# Access Compliance Report

## Public Rights-of-Way

Intersection ID: 5314	Main Street: PAVILION_BV	Cross Street: WHEATSIDE_DR	Location: SE
ADA ID: BEEDE52FD380	Ramp Type: Perp	Initial Pass/Fail: Fail	Overall Compliance: No
Severity Score: 21.25			
Codes/Mitigation Info/Possible Solution		Field Measurements/Component Compliance

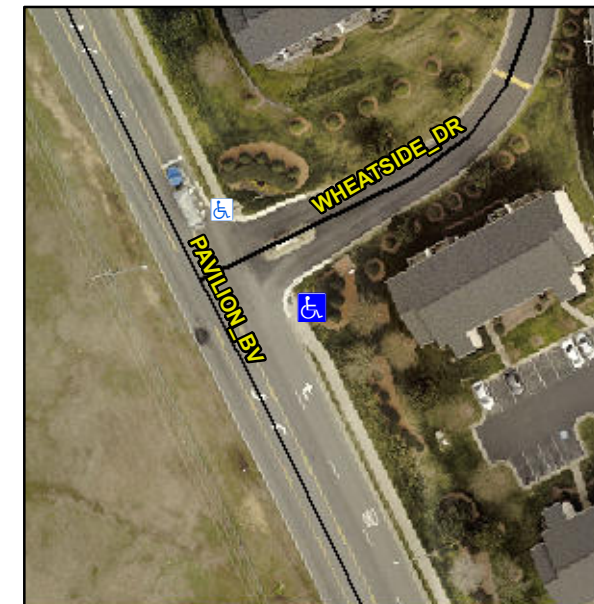
**Remove & Replace Entire Ramp.**

**R304.5.1, R304.5.3**
